10/670,773

Bunsho Kuramori

Office Action Summary

DETAILED ACTION

FIG. 2

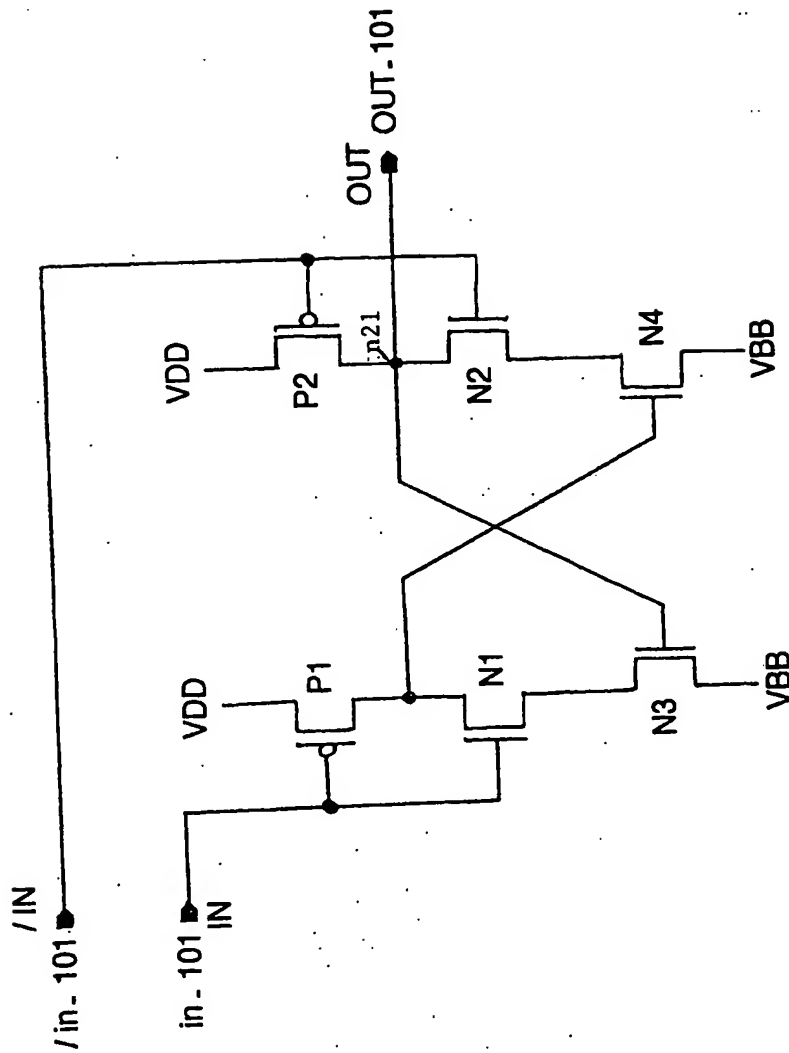
Approved
11-16-05
TLE
